1 Purpose of Document

This document summarizes the changes between the previous ASI4U silicon revision C and the current silicon revision E. These include requested UART design changes. The purpose of the redesign was to correct reported timing errors by the UART in the following modes: Master, Monitor, and Repeater. A problem with slave communication in special network constellations was also fixed.

Figure 2.1 Comparison of Valid MAN-Code Signal to Faulty MAN-Code Signal

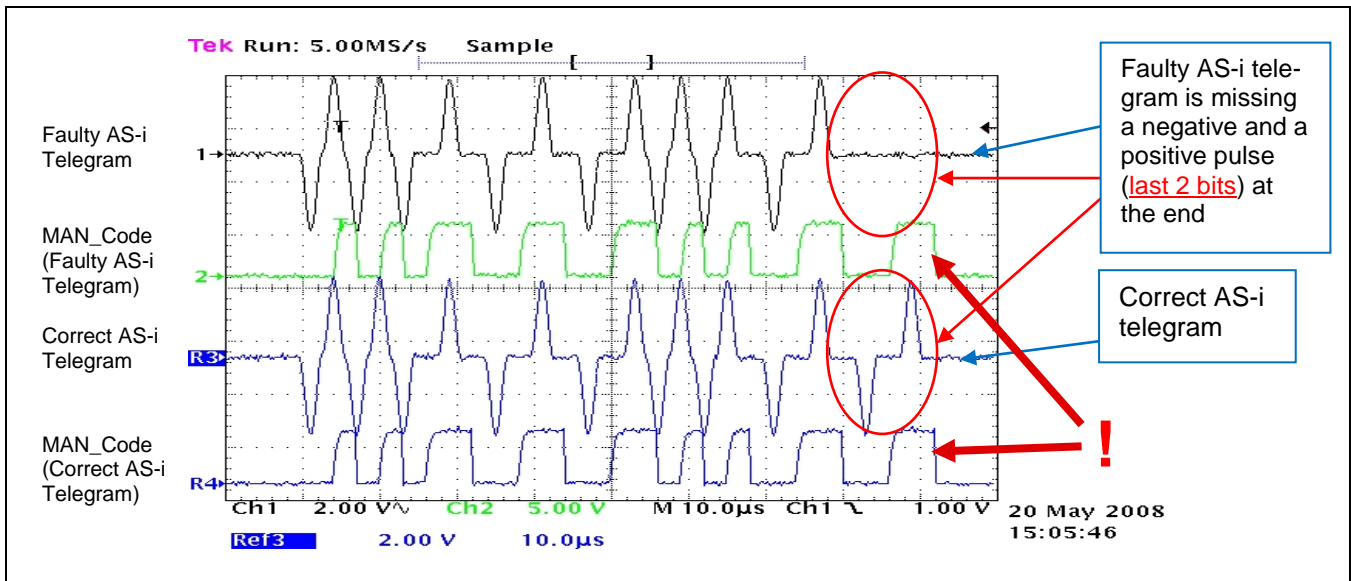
If the ASI4U revision C operates in Master Mode, Monitor Mode or Repeater Mode, the error signaling for an *End_Bit_Error* does not work correctly. In some special cases, the generated MAN-Code of a signal with an *End_Bit_Error* looks similar to the MAN-Code of a signal without any errors as demonstrated in Figure 2.1.

This malfunction of the ASI4U revision C results in an MAN-coded output signal that does not allow distinction between correct AS-I pulse sequences and pulse sequences that are shortened (missing one negative and one positive pulse). It occurs only under the following conditions:

- The parity of the signal is even.
- The last bit of the corrupt telegram is equal to binary 1.
- The *Stop_Bit* and the *Parity_Bit* or the *Start_Bit* and the *Control_Bit* are missing.
- If the *Start_Bit* and the *Control_Bit* are missing, the first pulse must have a negative polarity.

The following changes in the UART block were implemented in ASI4U silicon revision E:

1. The last pulse of the MAN-coded LED1 output signal is now always kept in ACTIVE state for 9 μ s if an ASI telegram with an *Endbit_error* is received.

The polarity of the ACTIVE State depends on the signal setting at the DI ports in Master Mode, Monitor Mode, and Repeater Mode. If DI2 and DI3 are driven by equal input signals, the MAN output signal at LED1 is configured ACTIVE LOW. If DI2 and DI3 are driven by unequal input signals, LED1 becomes inverted and is configured ACTIVE HIGH.

Since a 9 μ s-wide MAN pulse is an out-of-specification event for the AS-I MAN signal, it will allow the connected microcontroller to recognize the error in the AS-I pulse signal on the AS-I line.

Figure 3.1 Test for ASI4U Revision C Error in Master Pause Detection

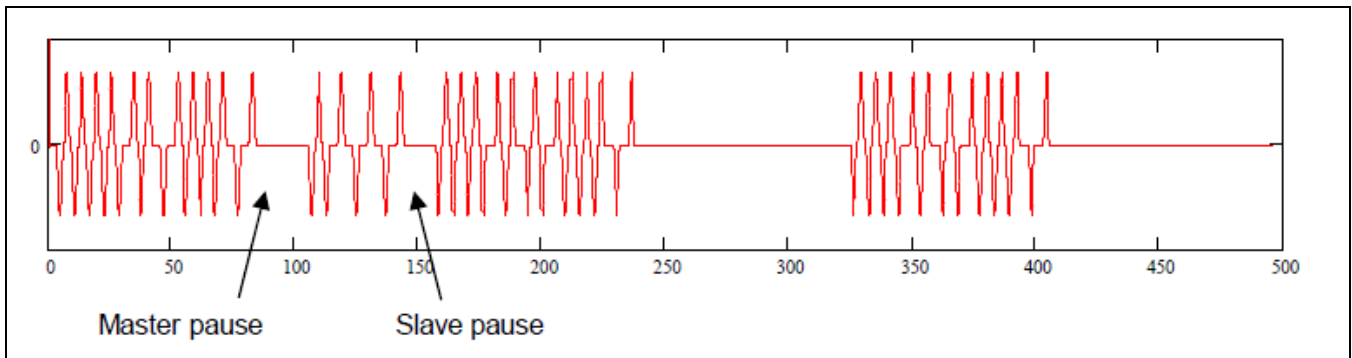
If the previous ASI4U revision C is operated in Slave Mode, the UART Master Pause detection does not always function correctly when the UART must listen to slave responses from a different slave. Depending on the actual AS-I line pulse timing, a slave response from a different slave is sometimes not recognized correctly, which results in a UART communication error. This prevents the Slave from understanding the next Master telegram correctly. If the Master telegram addresses the Slave itself, the error leads to a missing slave response and the Slave replies on a second repetition of the Master Call to its own address in asynchronous mode.

Figure 3.1 shows a telegram test case to reproduce the error. The AS-I signals shown in Figure 3.1 were generated by a signal generator that allowed sweeping the Master Pause and Slave Pause duration over the allowed specification limit. The first Master Call contains a different slave address than the tested slave. The second and third master calls address the tested slave. The tested slave replied with the erroneous behavior for certain Master pause and Slave pause scenarios only. The majority of the test cases were passed without error.

A new principle of AS-i telegram pause detection was implemented in ASI4U silicon revision E that is more precise and able to cover all valid timing scenarios for Master and Slave pauses. The new principle is now independent of the internal timing constraints of the UART state machine.
